Access Compliance Report

Public Rights-of-Way

(Curb Ramps)

Intersection ID: 24479	Main Street: MEGINGTON_DR	Cross Street: SPRINGS_FARM_LN	Location: NW
ADA ID: CBD40F4695B1	Ramp Type: PerpDiag	Initial Pass/Fail: Fail	Overall Compliance: No
Severity Score: 8.75			
Codes/Mitigation Info/Possible Solution		Field Measurements/Component Compliance

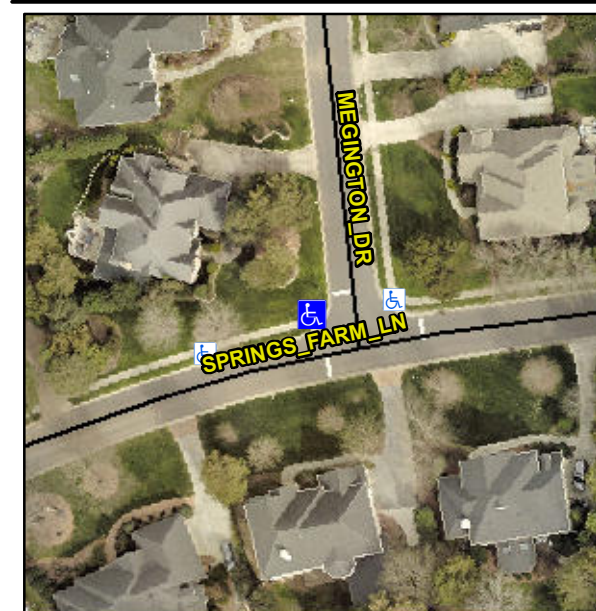
Compliance	Description	Data	Compliance	Description	Data
N/A	Ramp Length (in)	96.0	Yes	Ramp Slope (%)	5.7
No	Ramp Width (in)	47.0	Yes	Ramp XSlope (%)	1.7
N/A	Flare Type LT	N/A	N/A	Flare Type RT	N/A
N/A	Flare Slope LT (%)	N/A	N/A	Flare Slope RT (%)	N/A
N/A	Flare Traversable LT?	N/A	N/A	Flare Traversable RT?	N/A
N/A	Landing Length (in)	N/A	N/A	DWS Provided?	N/A
N/A	Landing Width (in)	N/A	N/A	DWS Contrast?	N/A
N/A	Landing Slope (%)	N/A	N/A	DWS Length (in)	N/A
N/A	Landing X Slope (%)	N/A	N/A	DWS Full Width?	N/A
N/A	Landing Curb? (Y/N)	N/A	N/A	DWS Offset (in)	N/A
N/A	Shared Landing?	N/A			
N/A	Gutter Ponding?	N/A	N/A	Gutter Slope (%)	N/A
N/A	Gutter Lip Ht (in)	N/A	N/A	Gutter X Slope (%)	N/A
N/A	Painted X Walk1?	No	N/A	Painted X Walk2?	No
	X Walk 1 Direction	To S		X Walk 2 Direction	To E
N/A	X Walk 1 Width (in)	N/A	N/A	X Walk 2 Width (in)	N/A
	X Walk 1 Slope (%)	4.6		X Walk 2 Slope (%)	3.1
	X Walk 1 X Slope (%)	2.3		X Walk 2 X Slope (%)	2.6

N/A	Ramp inside XWalk1?	N/A	N/A	Ramp inside XWalk2?	N/A
	Road Slope (%)	2.1	N/A	Clear Space?	N/A
	Road X Slope (%)	6.8	N/A	Clear Space to XWalk (in)	N/A
N/A	Any Obstructions?	N/A	N/A	Storm Grate/Utility Hazard?	N/A
	Obstruction Type			Storm Grate/Utility Type	
		N/A			N/A
		Yes		Surface Condition? (G/P)	Good

Possible Solutions:

Remove & Replace Curb Ramp With Two New Directional Ramps or Equivalent.
